RE: Marion County High School Renovation & Addition  
Lebanon, Kentucky  
BG 21-103  
RTA 2046

The following is a listing of proposed alternates or VE items for the Marion County High School Renovation for the consideration of the Board. The costs associated with these items are estimates only.

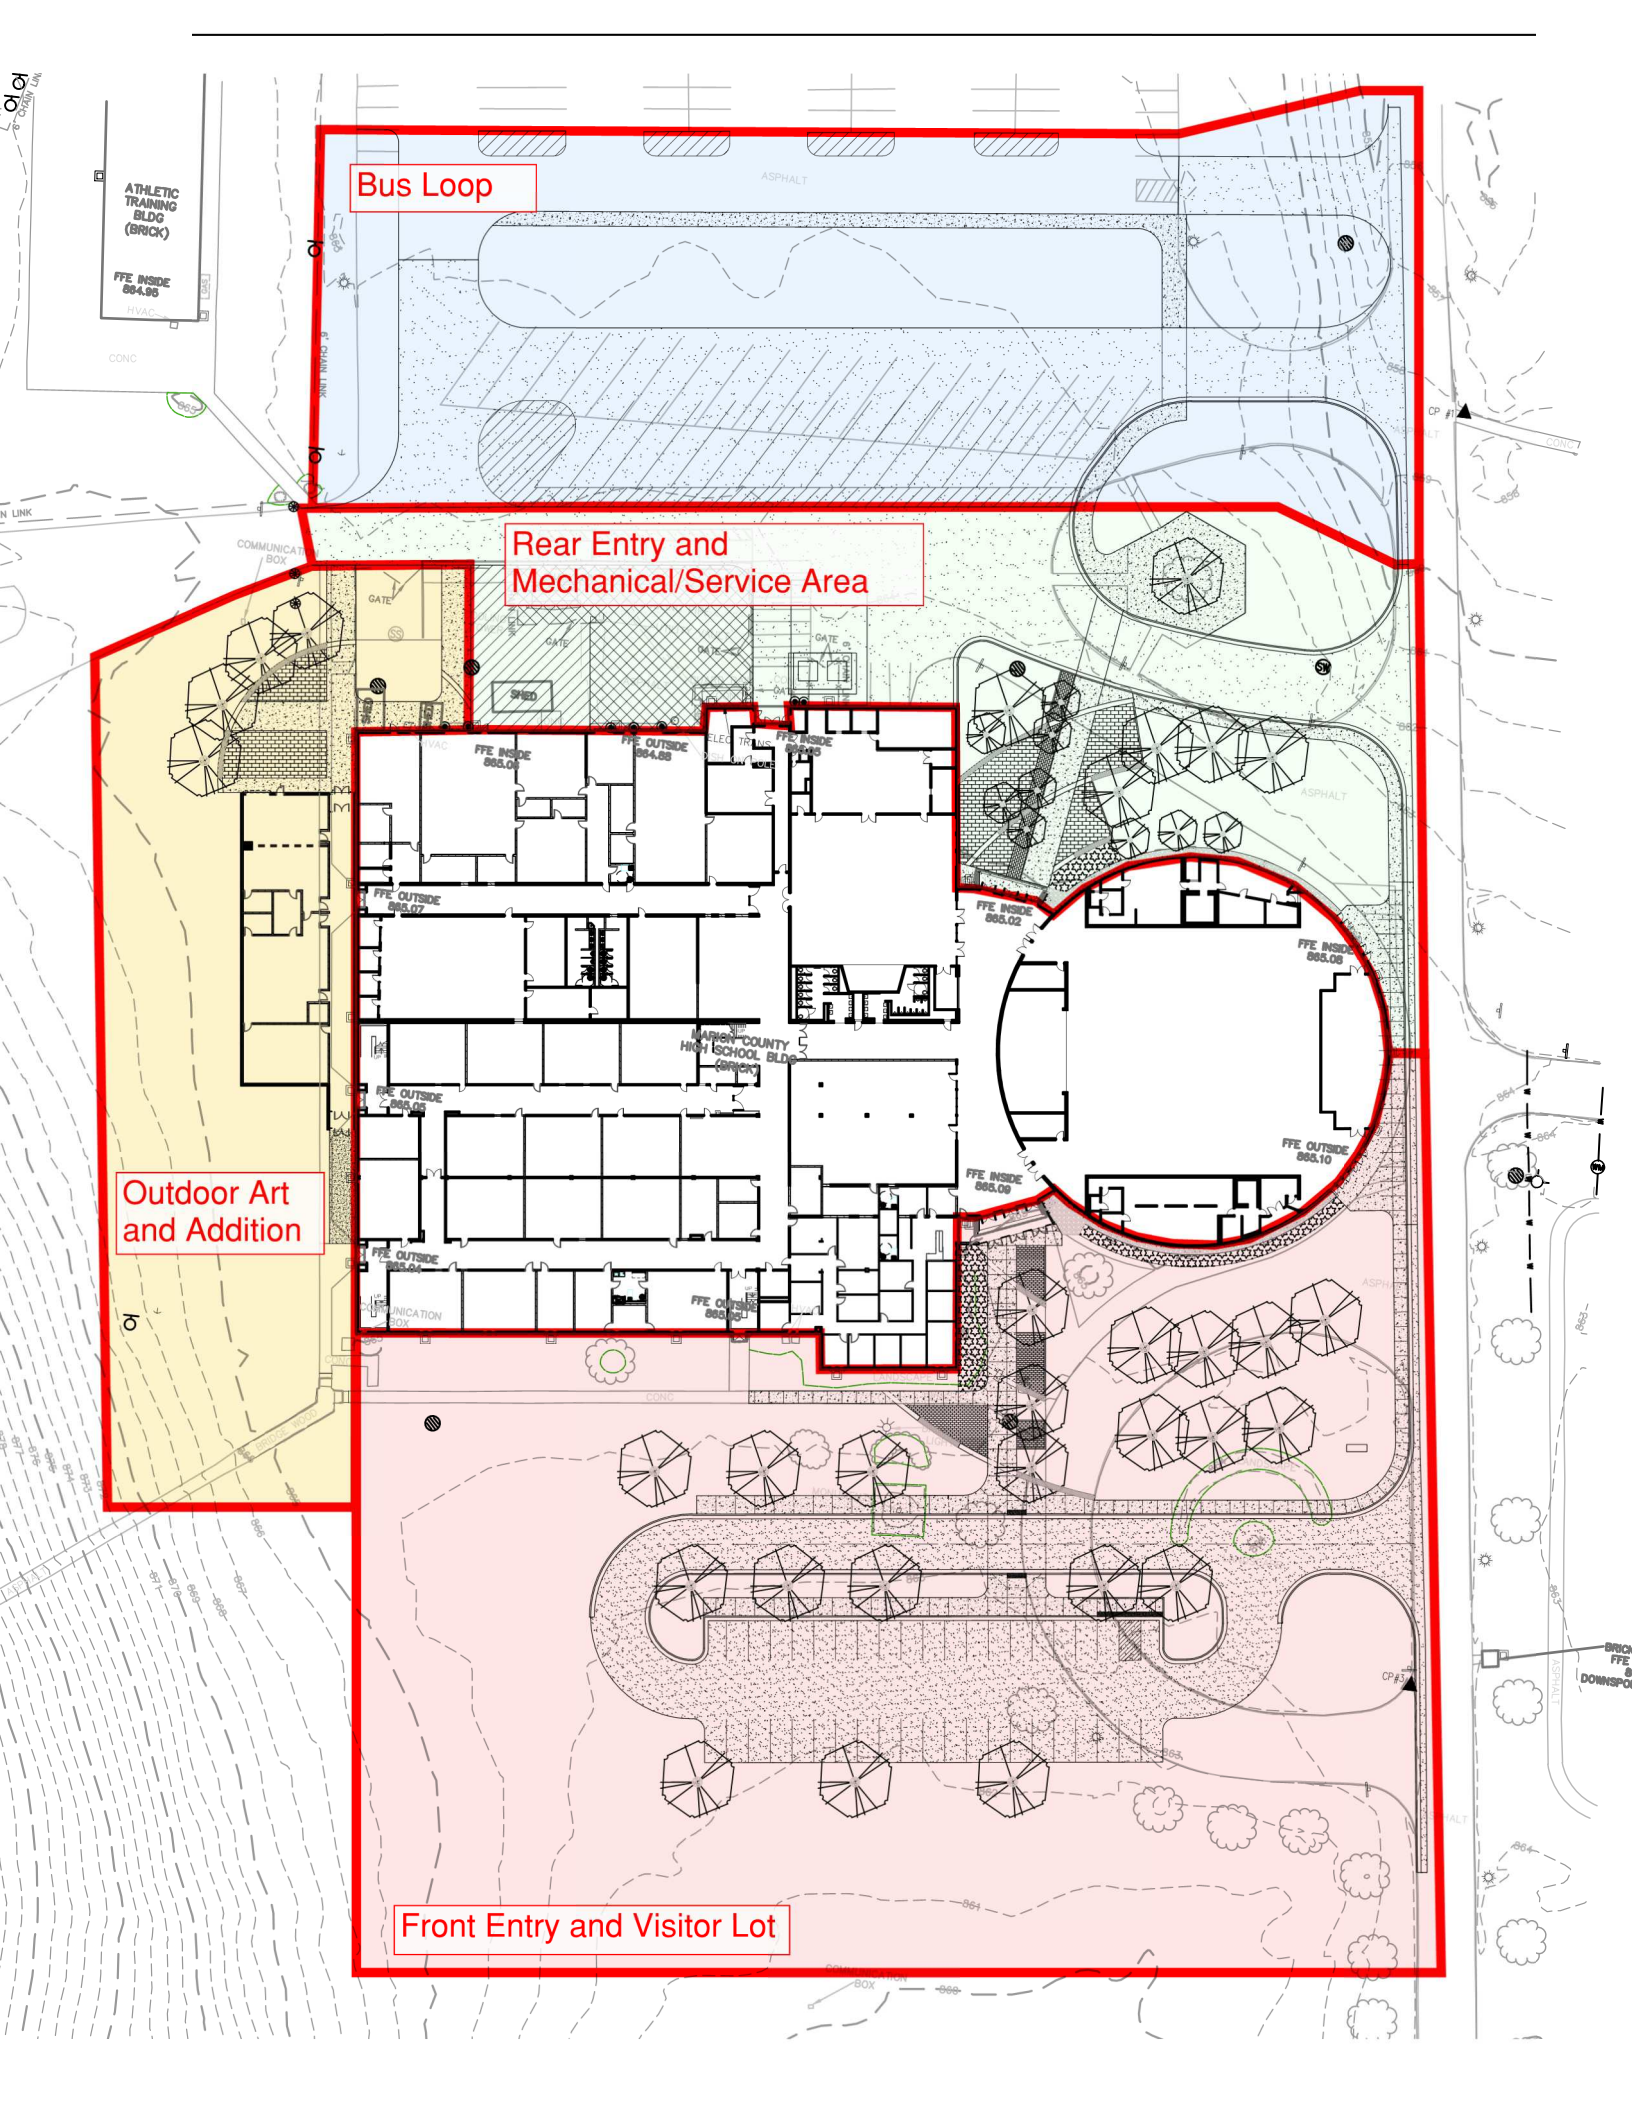
- a. The site development has been broken down into 4 areas with corresponding costs. Refer to the attached site plan for corresponding areas.

**Bus Loop: \$355,000**

**Rear Entry and Mech/Service Area: \$635,000**

- i. This only reflects work that can be eliminated with that improvement. There will still be significant work in this area (i.e. grease interceptor, transformer, fluid cooler, etc.)

**Outdoor Art: \$227,000**

**Front Entry: \$675,000**
